Groundwater Remedy Phase 2A Construction, PG&E Topock Compressor Station, Needles, California

Work Variance Request #14 – Proposed Installation of Pipeline C18 at Current Post-NTCRA Elevation and Addition of Aggregate-Based Access Road in East Ravine for Remedy Operation and Maintenance

Variance Request No.: 14

TOPOCK GROUNDWATER REMEDIATION PROJECT
PIPELINE - GRADING PLAN
PIPELINE "C18"
STA 0+00 TO 8+90
GAS TRANSMISSION & DISTRIBUTION
PACIFIC GAS AND ELECTRIC COMPANY
SAN FRANCISCO, CALIFORNIA

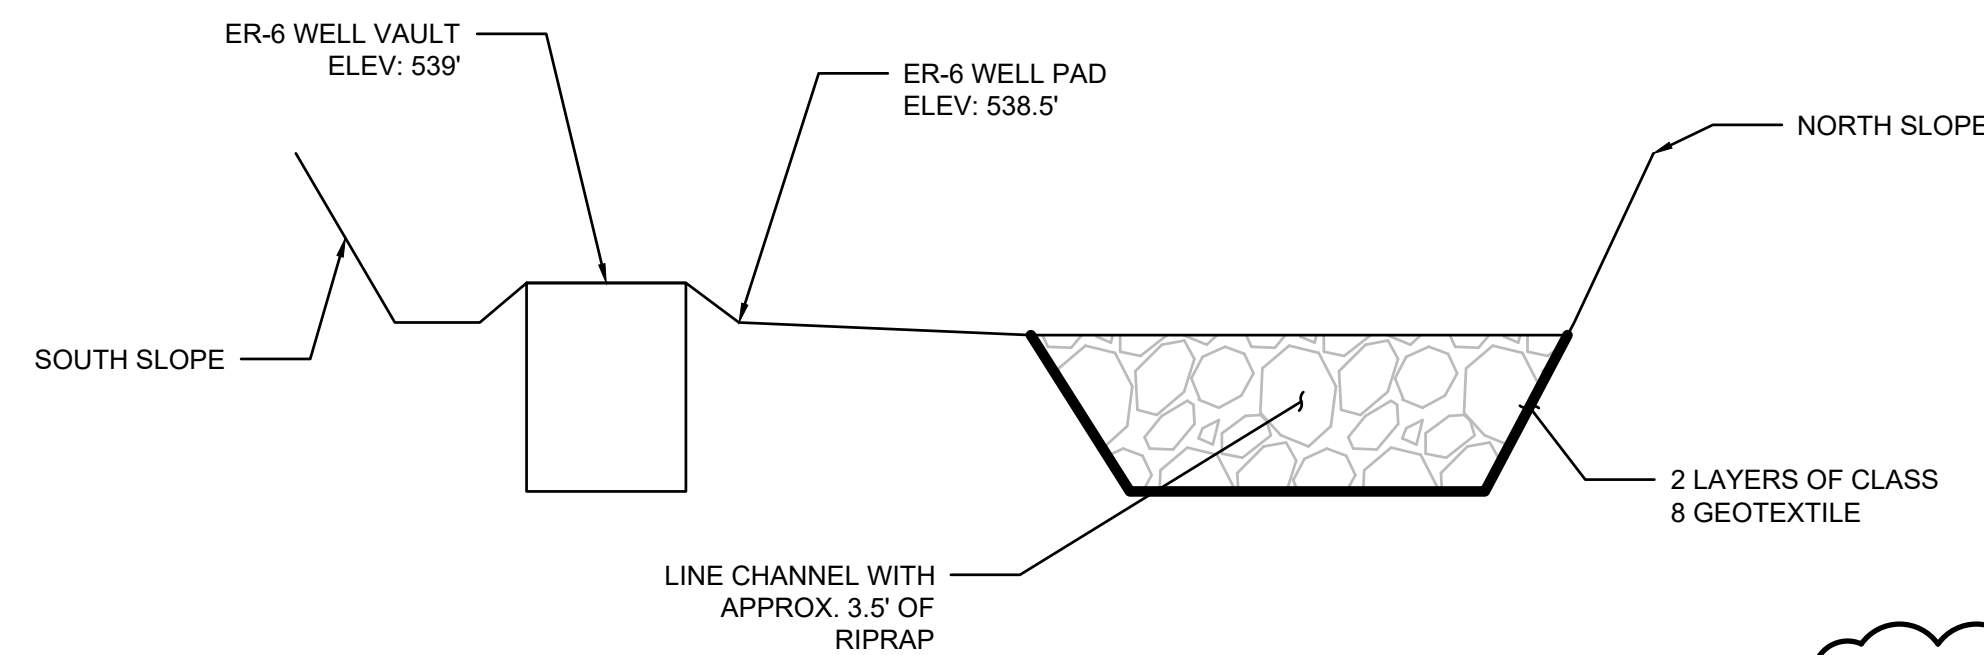
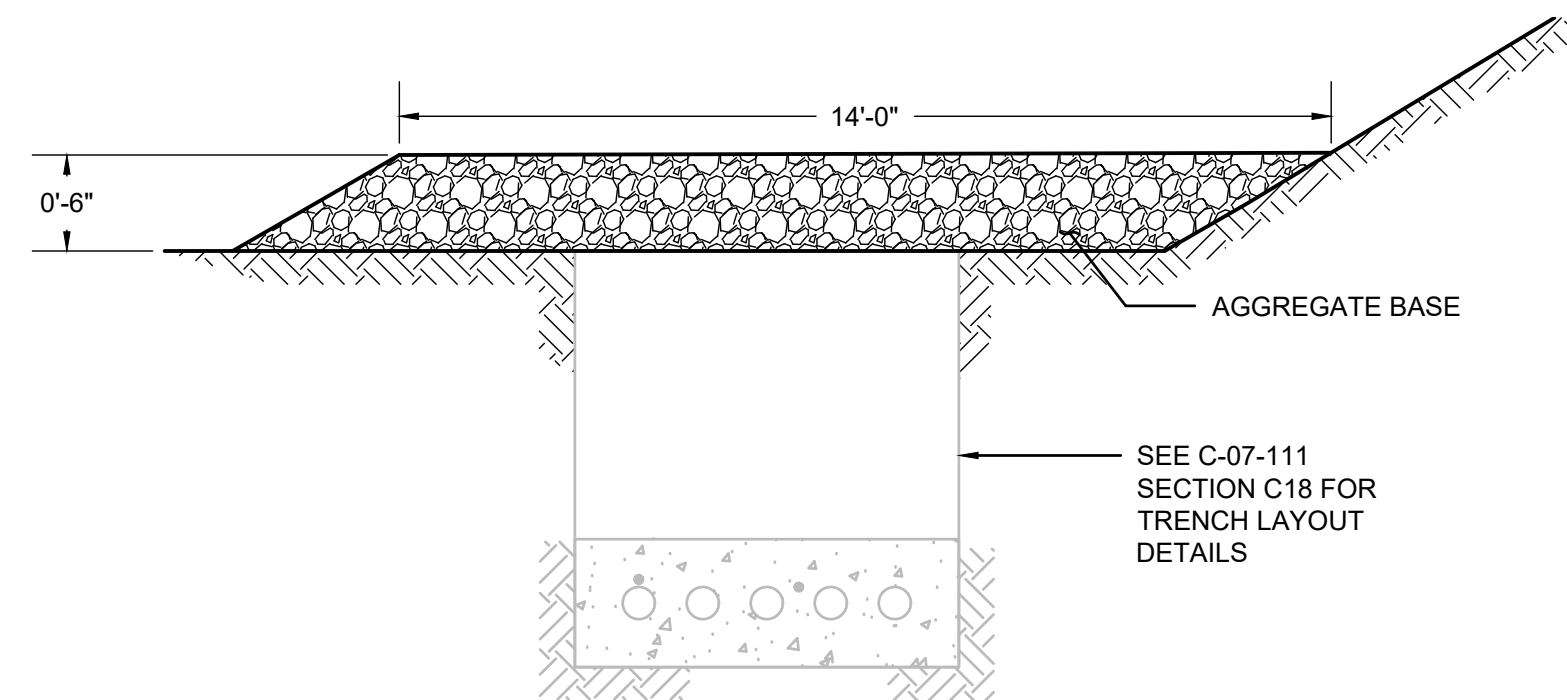
Consistent with that rationale, PG&E proposes to install remedy pipeline C18 in the East Ravine at current post-NTCRA elevation, instead of at the higher pre-NTCRA elevation in the 2015 Final Design. This will reduce the need to import approximately 5,000 cubic yards of fill materials to backfill the East Ravine to pre-NTCRA elevation. No material changes to the pipeline C18 alignment, as approved in WVR #10 (can be downloaded via [Link](#)), is proposed.

1. Import back fill: a reduction of approximately 4,227 cubic yards (5,000 cy reduction by not backfill East Ravine plus 773 cubic yards of fill estimated for pipeline C18 [see attached C-07-61])
2. Import riprap: an increase of approximately 198 cubic yards
3. Import AB: an increase of approximately 245 cubic yards
4. Access road length: an increase of 970 feet

C18 WEST (STA 7+25 TO 8+90) CUT/FILL REPORT		
CUT	FILL	NET
0 CU.YD.	434 CU.YD.	434 CU.YD.

C18 EAST (STA 2+50 TO 6+00) CUT/FILL REPORT		
CUT	FILL	NET
18 CU.YD.	339 CU.YD.	321 CU.YD.

ESTIMATED RIPRAP AND SURFACING FILL	
RIPRAP 198 CU.YD.	AGGREGATE BASE 245 CU.YD.

2 TYPICAL SECTION OF EAST RAVINE ACCESS ROAD
NOT TO SCALE
C-07-61

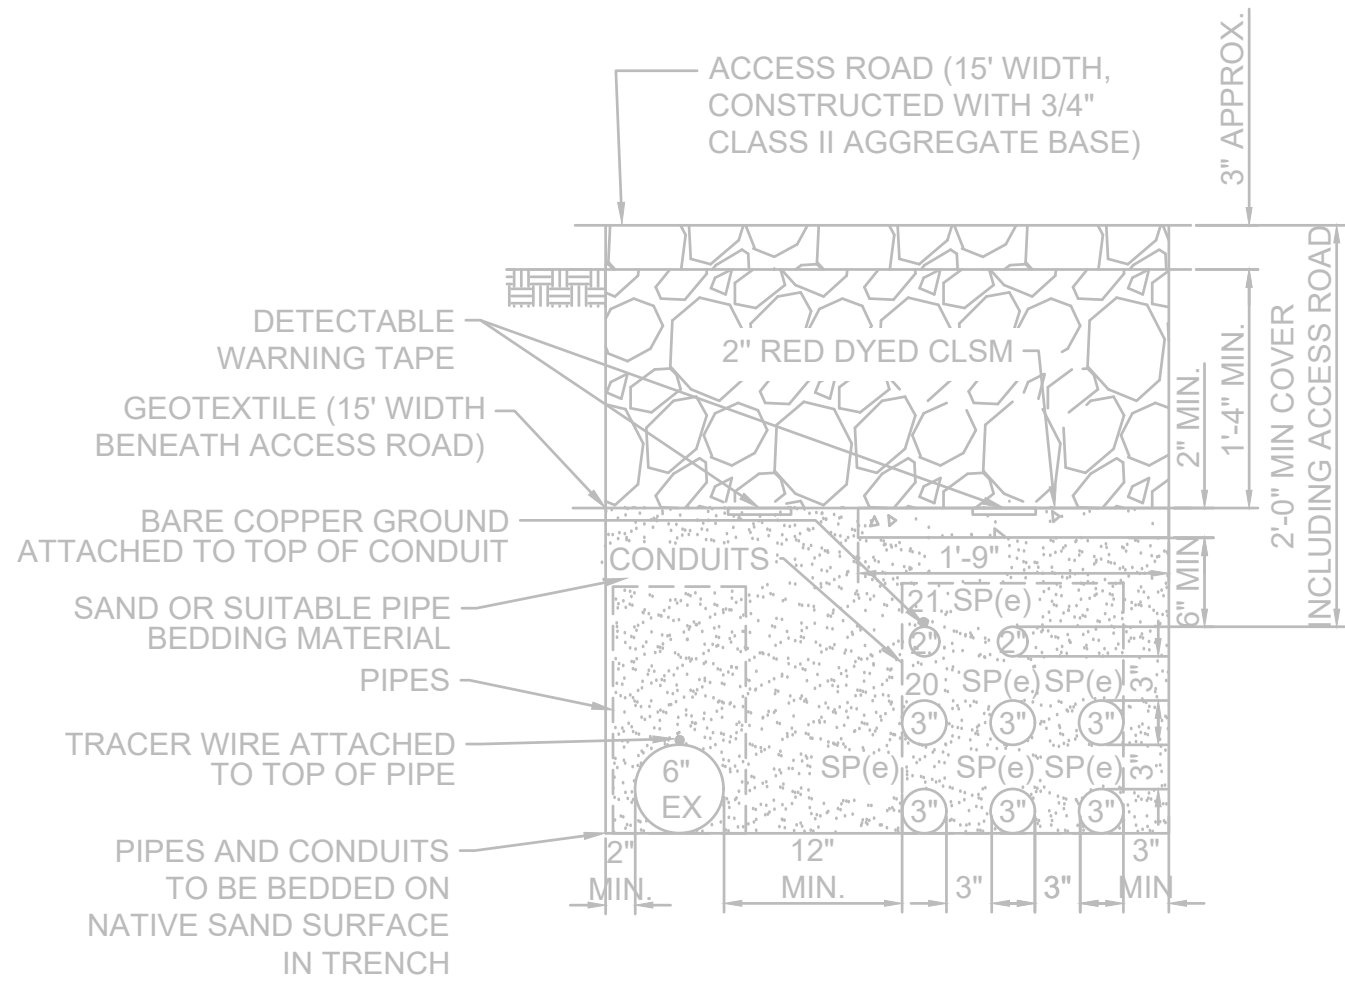
B. Justification for an aggregate-based (AB) access road in the East Ravine for the operation and maintenance (O&M) of remedy wells, monitoring wells, and pipeline

Figure 4.3-2 of the Construction/Remedial Action Work Plan (C/RAWP) shows an existing access route in the East Ravine. To support the remedy O&M activities for remedy wells and pipeline in the East Ravine, it is anticipated that this access dirt route would require frequent maintenance resulting in repeated soil disturbance. Therefore, to minimize soil disturbance, PG&E proposes to construct a 14-foot wide, aggregate-based (AB) access road on top of the pipeline C18 alignment. This AB access road would require less maintenance and minimize the level of soil disturbance over the anticipated decades-long duration of the Topock remediation project.
